DRAFT
Environmental Impact Statement

Appendix 17B

Supplemental PCN Information

The Belleayre Resort at Catskill Park

Figure 16

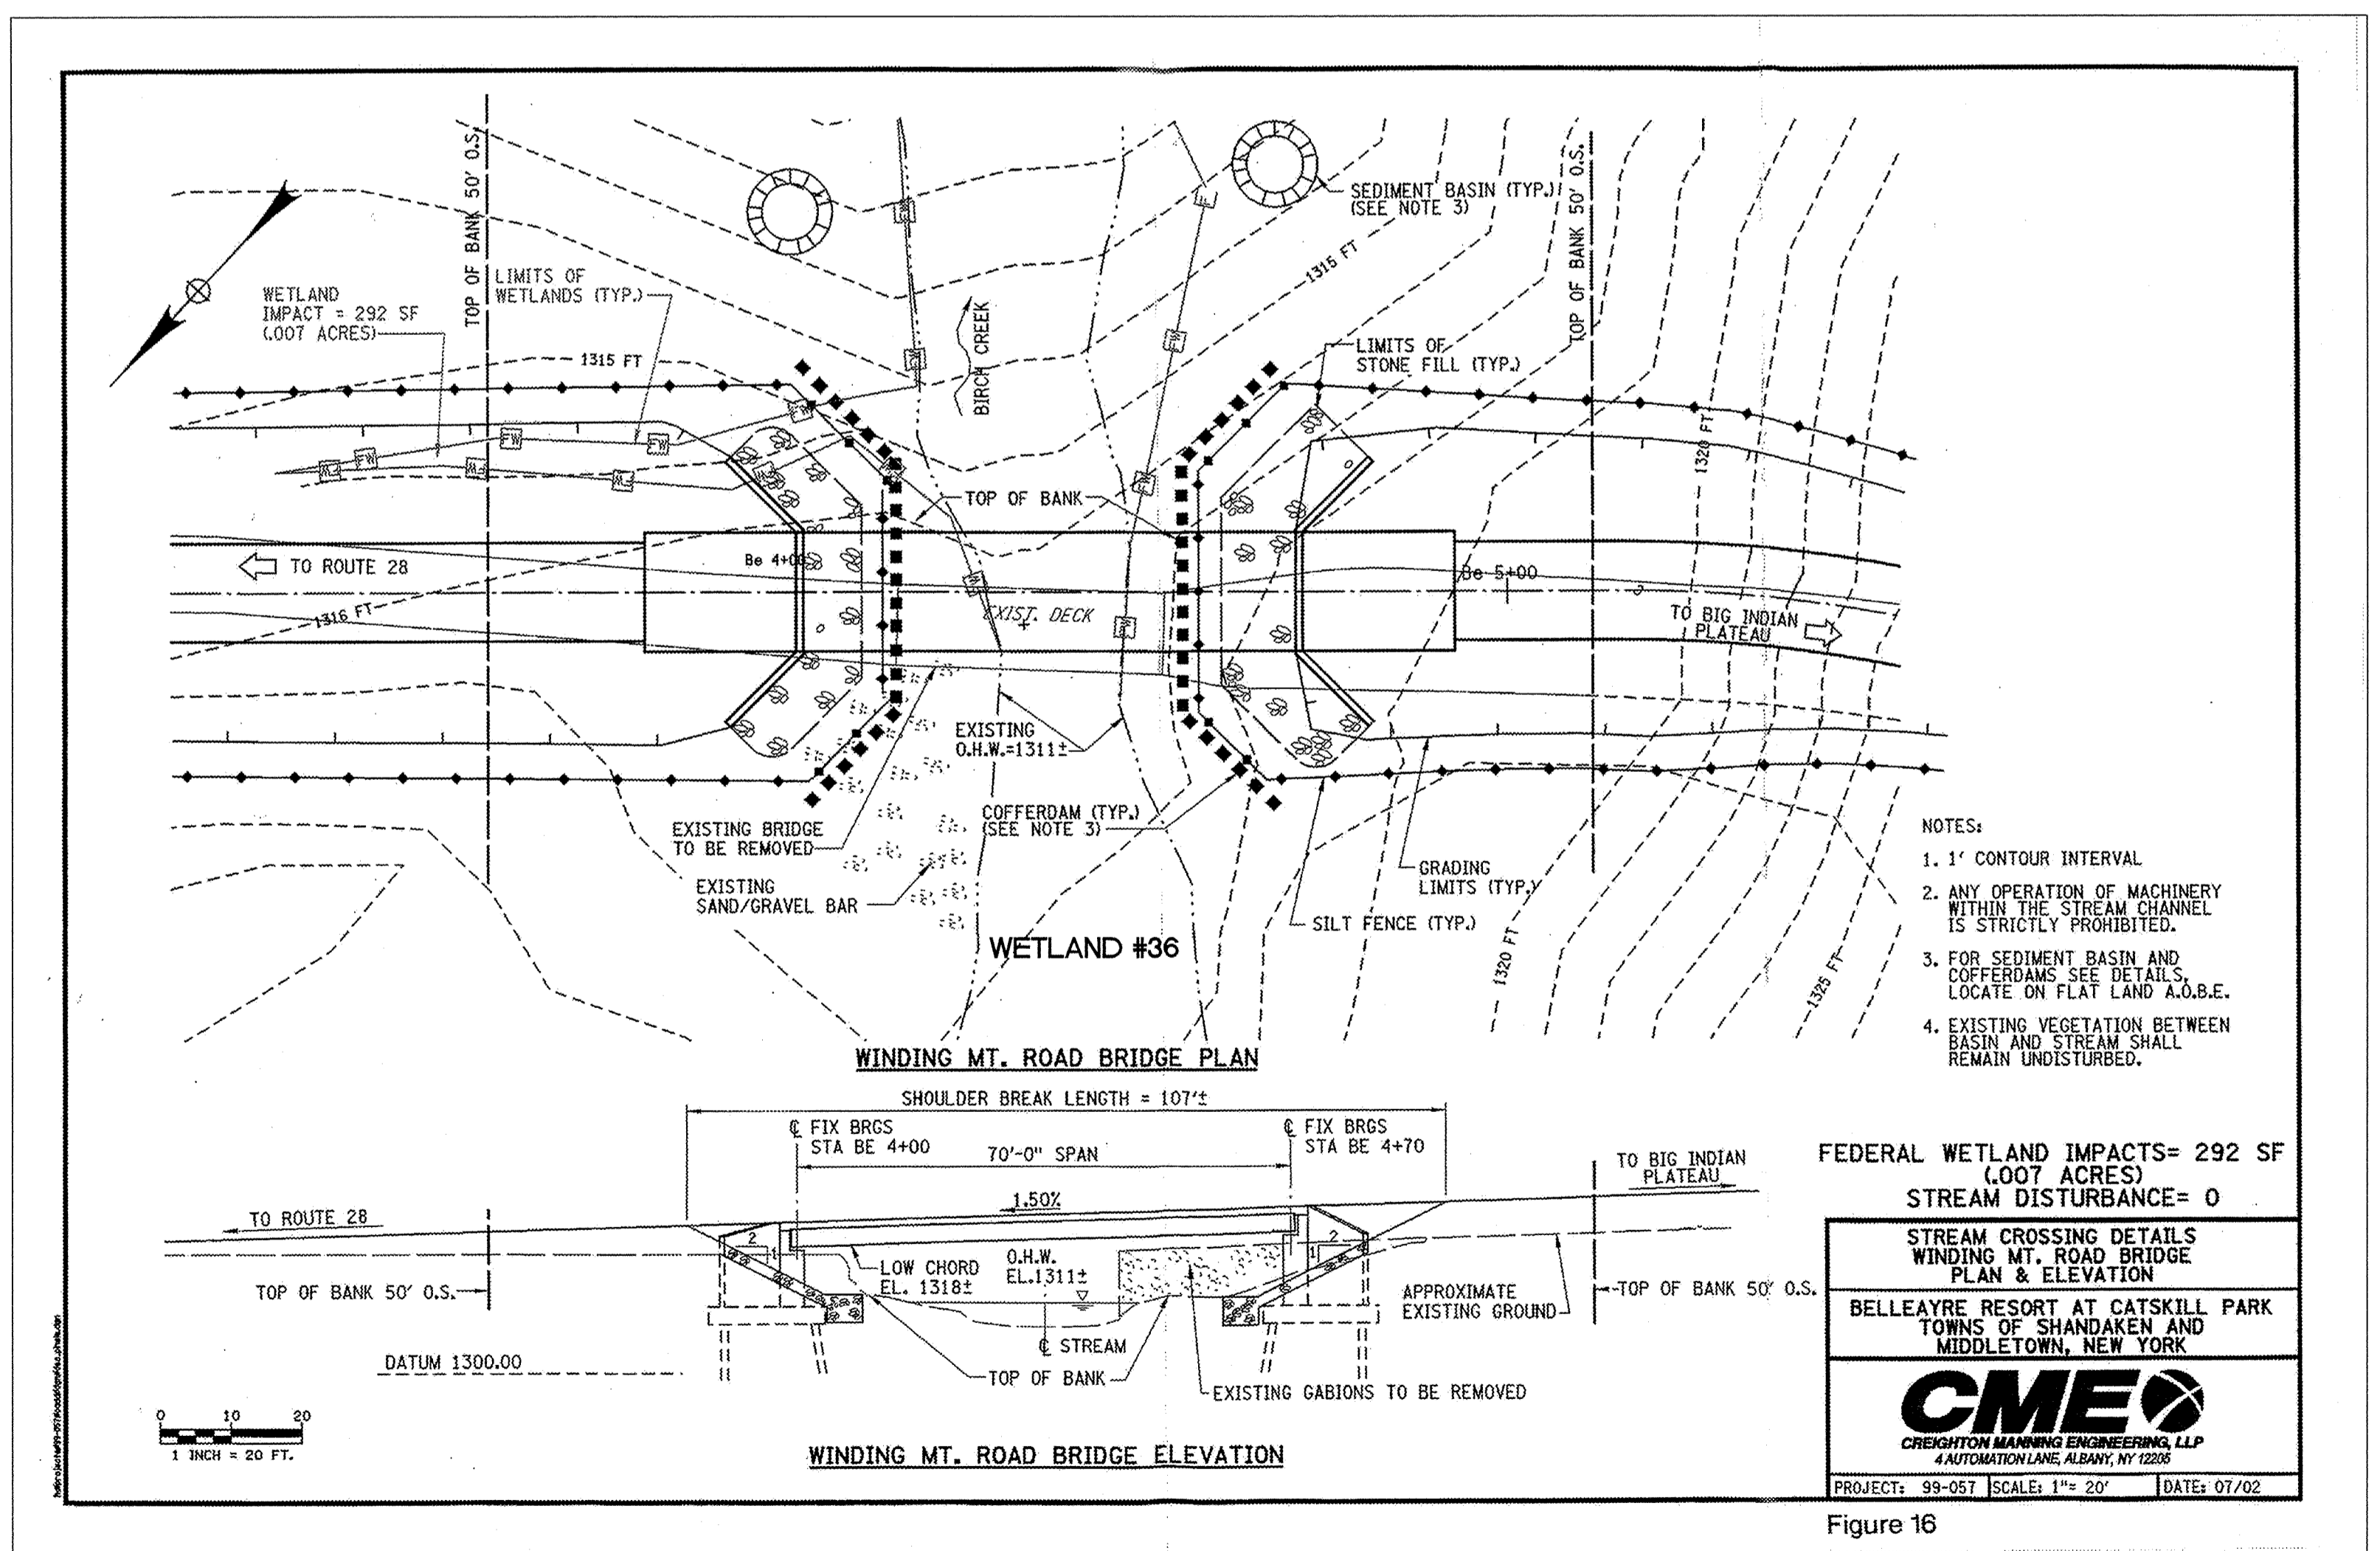
Figure 16 has been added to Detail Sheet D-2.

FIGURE 17

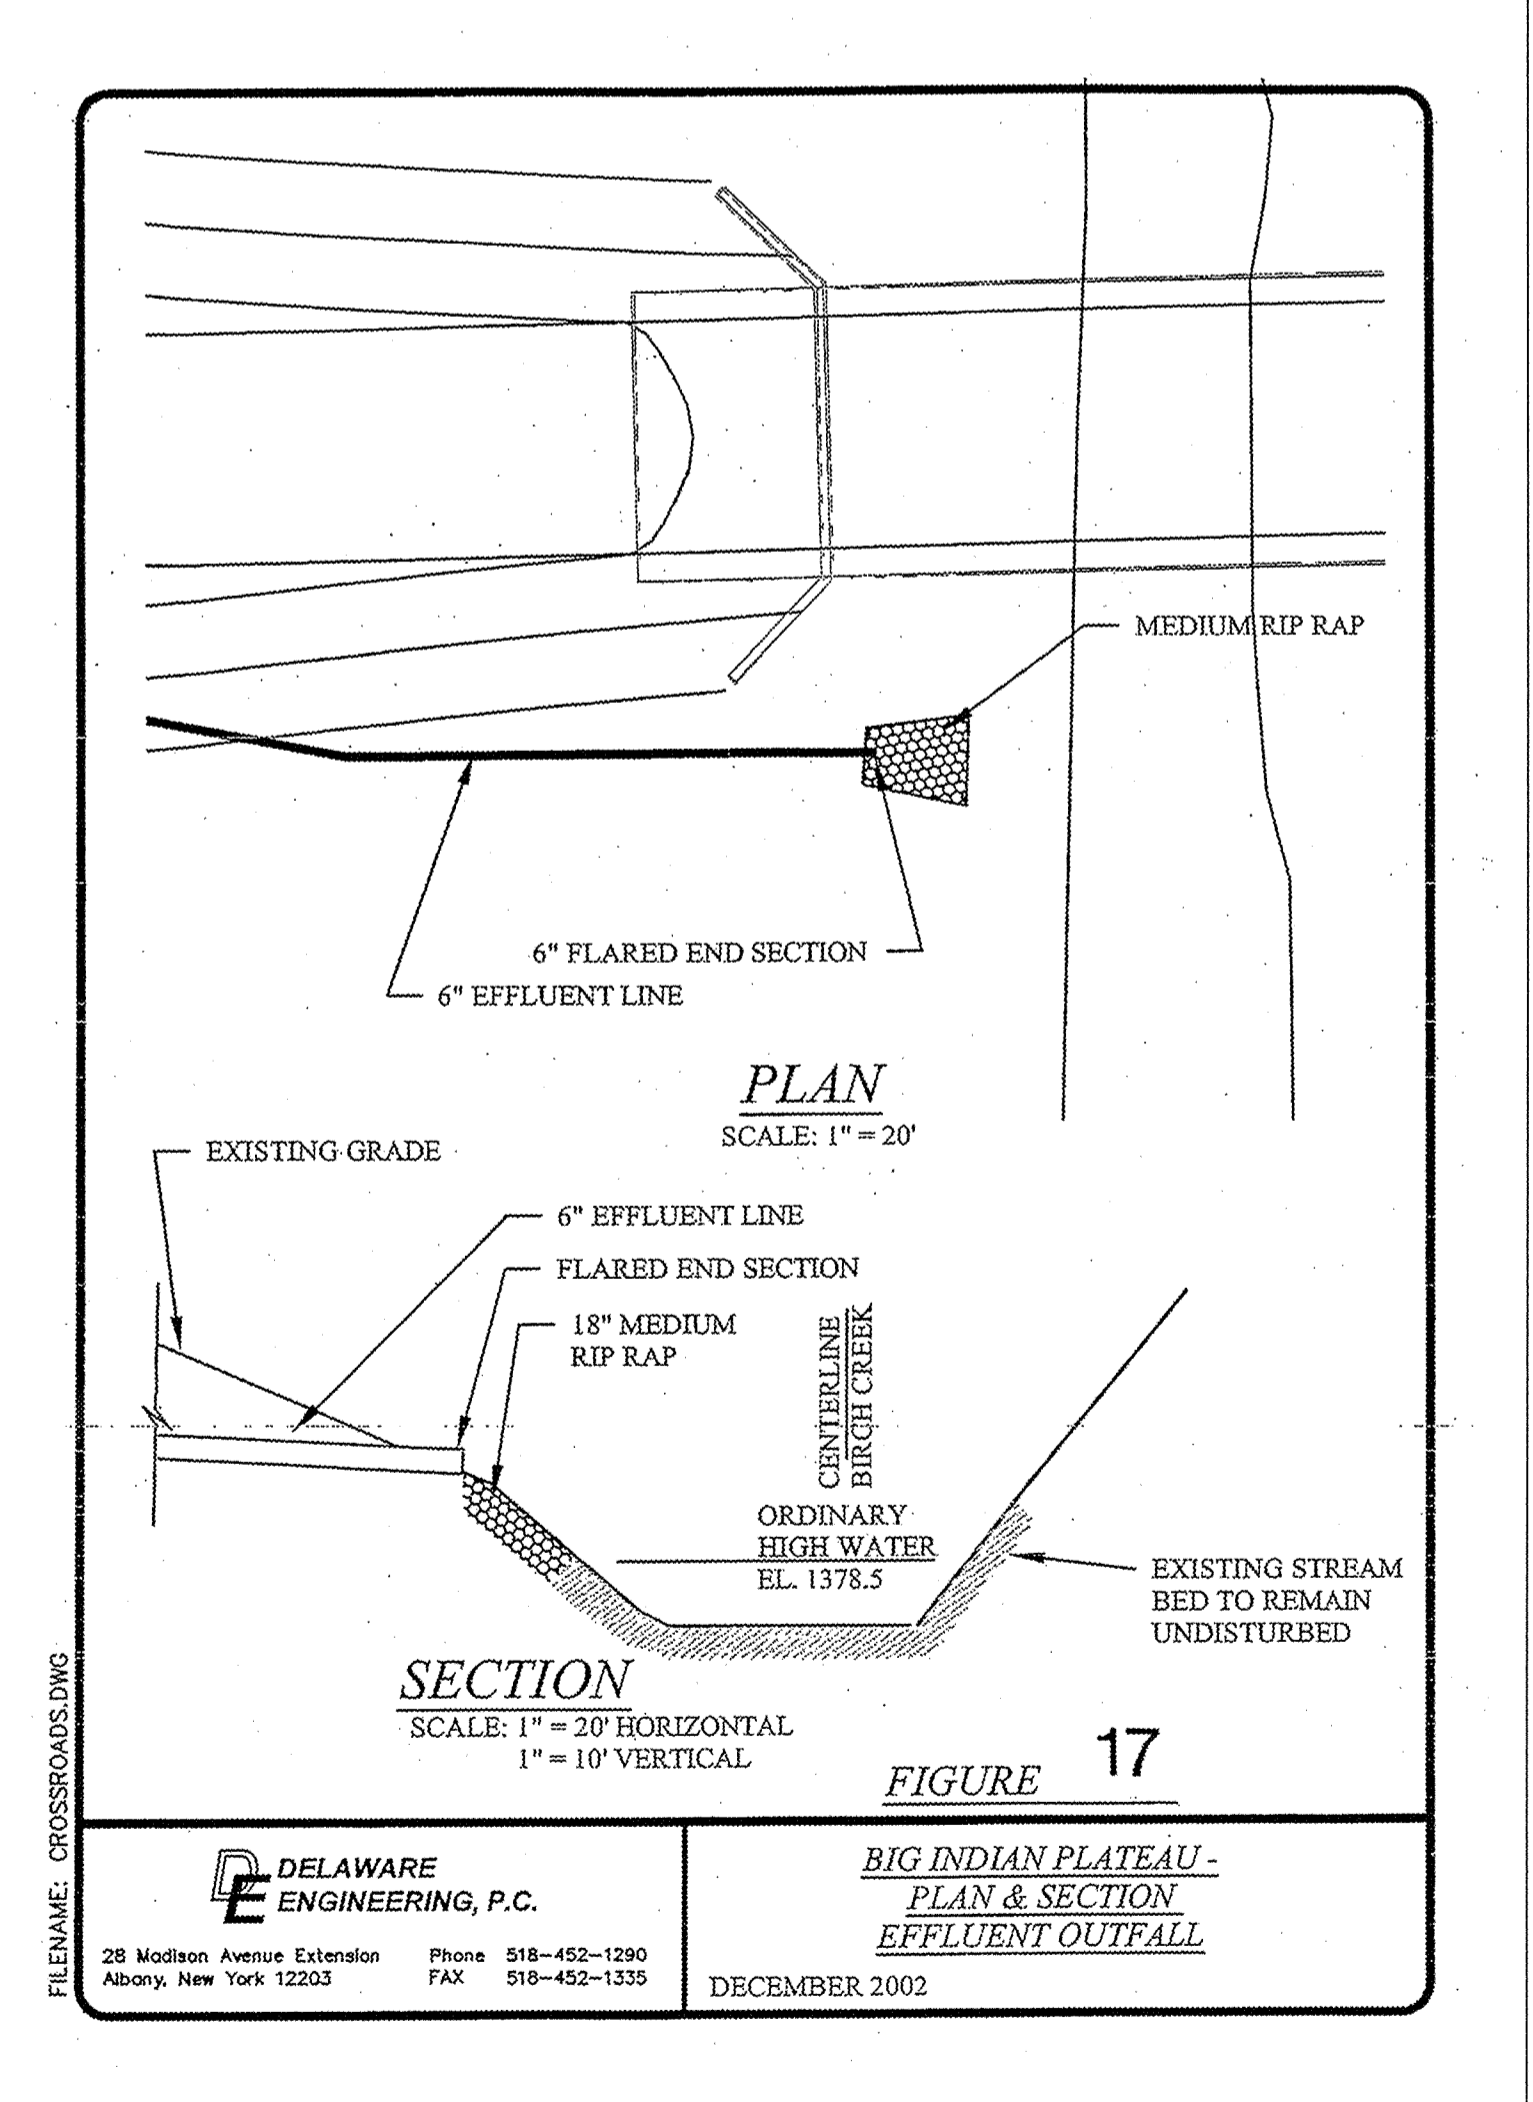
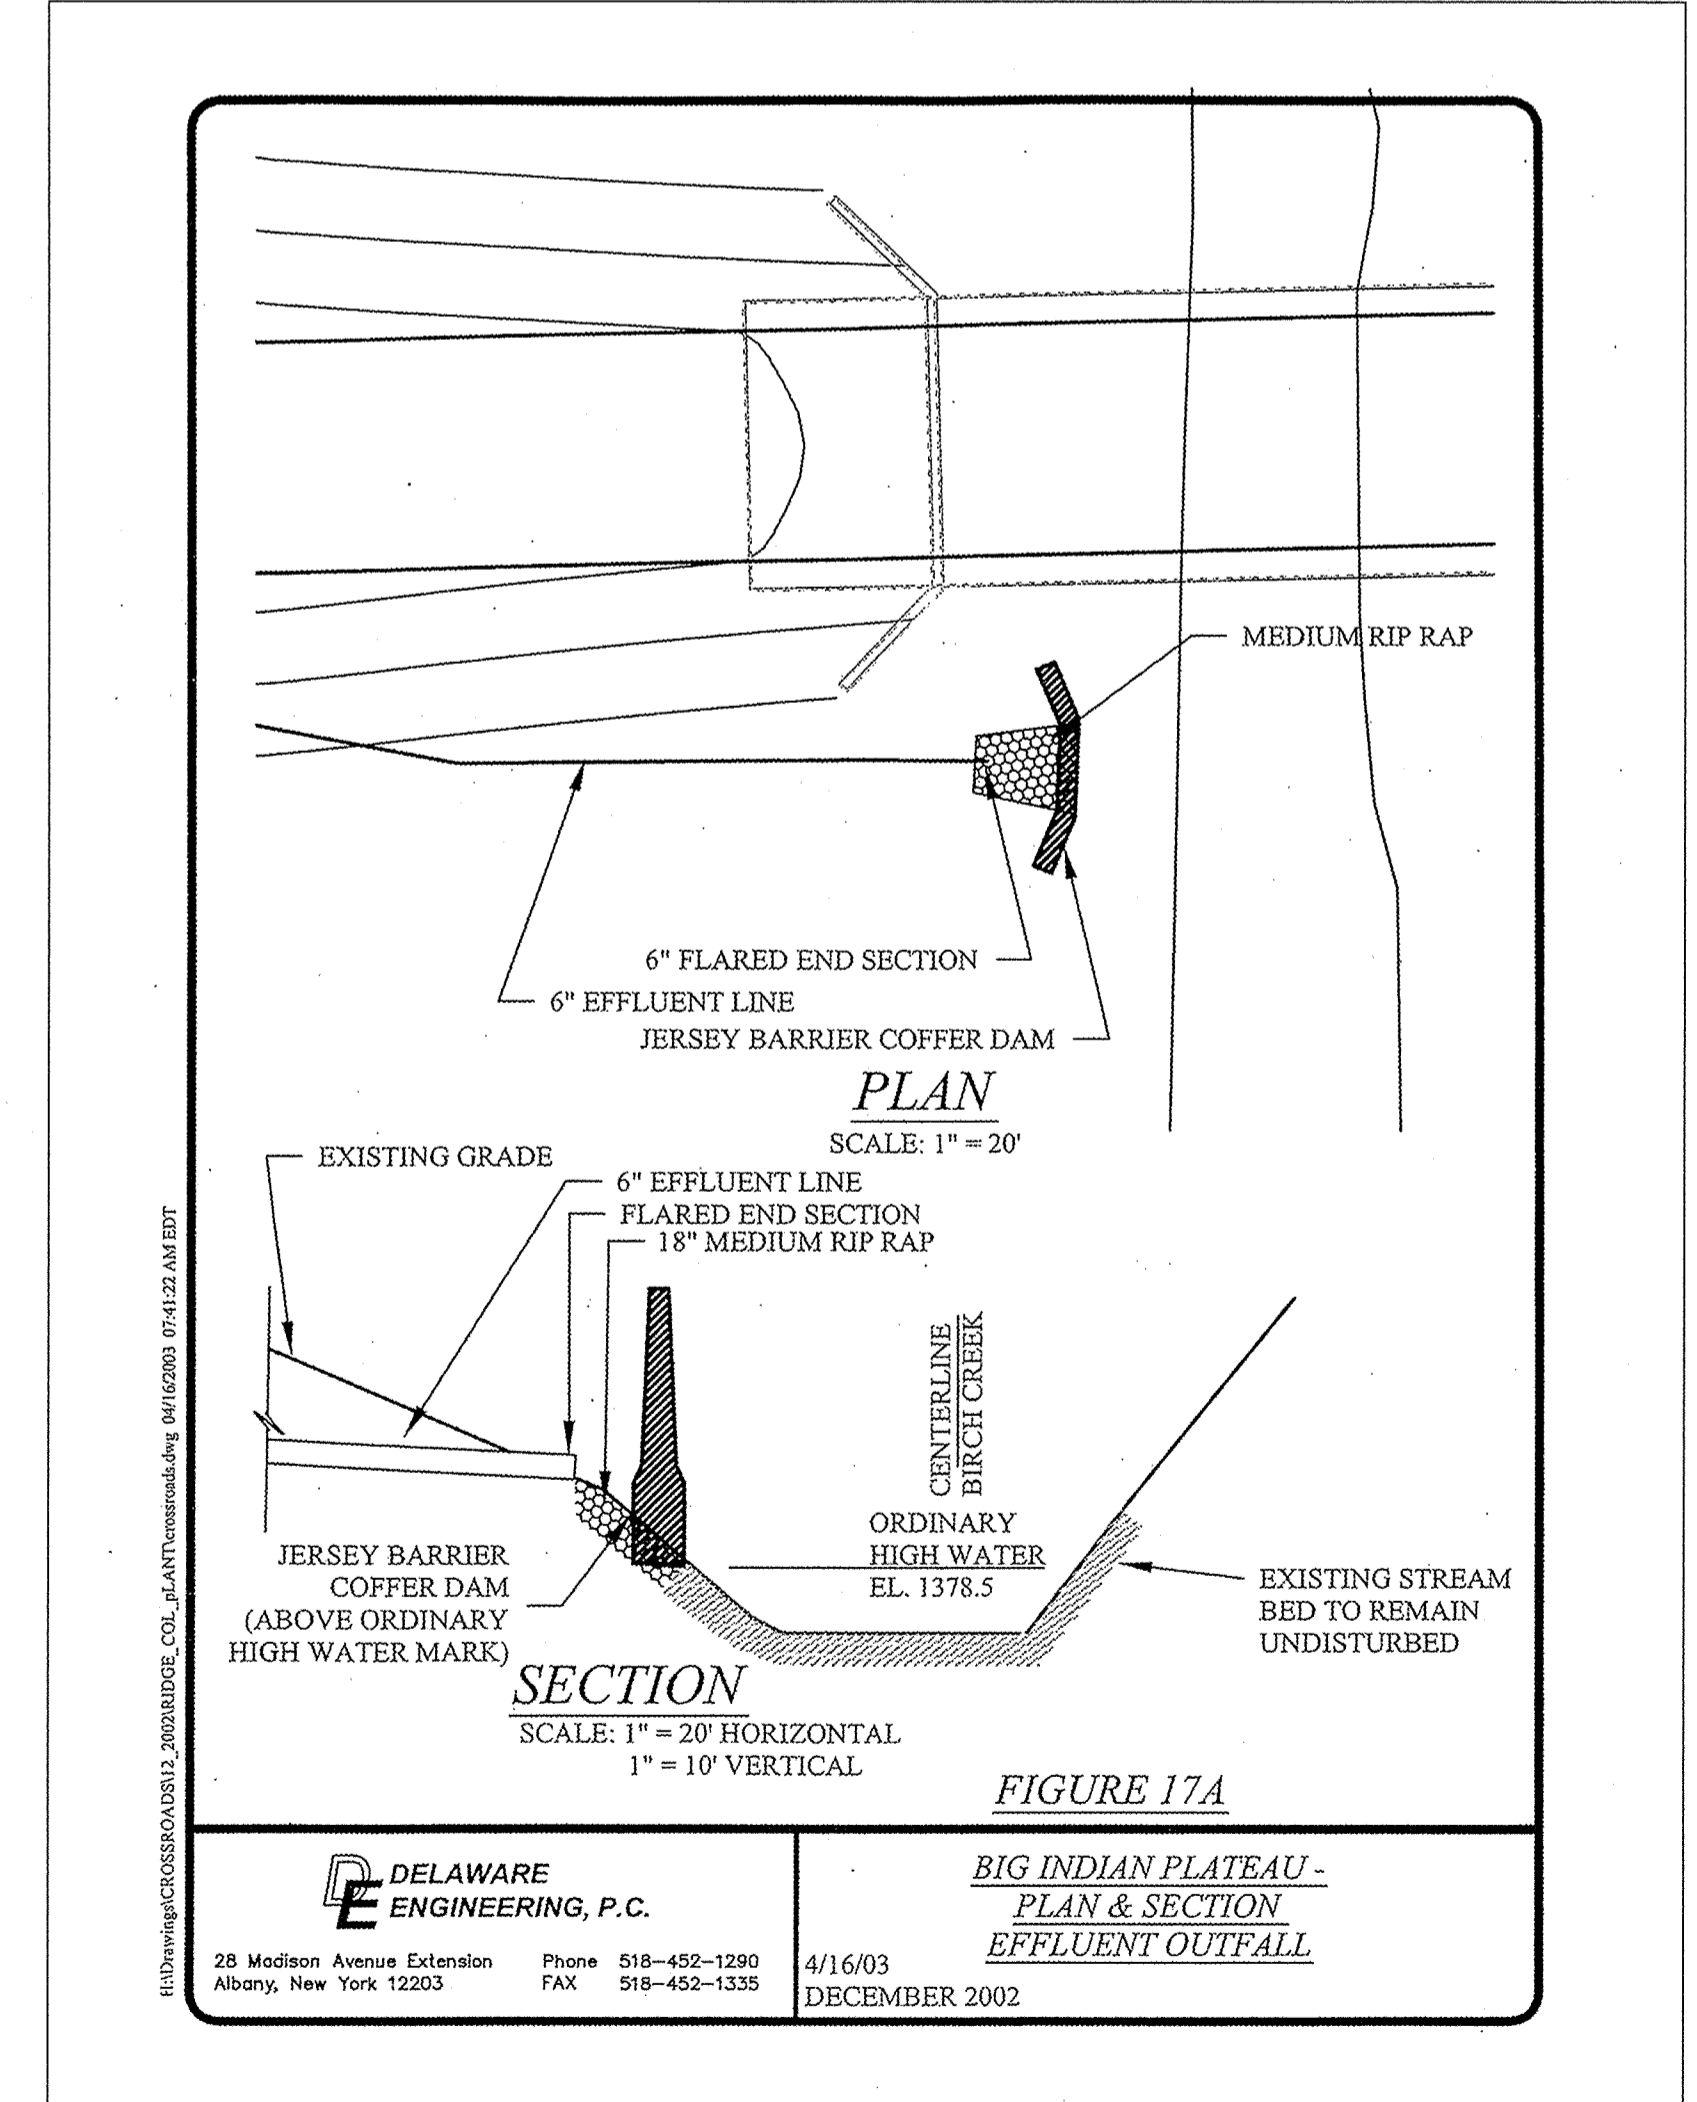
SG-6 now includes the proposed outfall for the Big Indian Plateau wastewater treatment plant (above ordinary high water) which is shown in detail on Figure 17 which has been added to Detail Sheet D-2.

The area of excavation around the outfall would be limited to pipe trenching that will be backfilled and the area where rip rap would be placed on the south side of the stream bank. Material to be excavated and removed for rip rap placement shown on Figure 17 would be above the ordinary high water mark (none below OHWM) totaling six (6) cubic yards from an area covering 90 square feet.

Figure 17A on Detail Sheet S-2 shows the location of the proposed jersey barrier coffer dam above the ordinary high water mark with no area to be temporarily filled below the OHWM. It is envisioned that the cofferdam may be in place for a week to ten days during construction of the outfall. Right after the cofferdam is removed the proposed rip rap will be installed as per the plans. No dewatering below the OHWM will be required.

Figures 17 and 17A. Figures 17 and 17A on Sheet D-2 have been revised to clarify the proposed outfall and the wetland boundary. Eight copies of revised Sheet D-2 are

attached. The plan and section views in these detail figures now include the delineated wetland boundaries and illustrate how the outfall and associated riprap are proposed outside the wetland boundary (and above the ordinary high water mark).
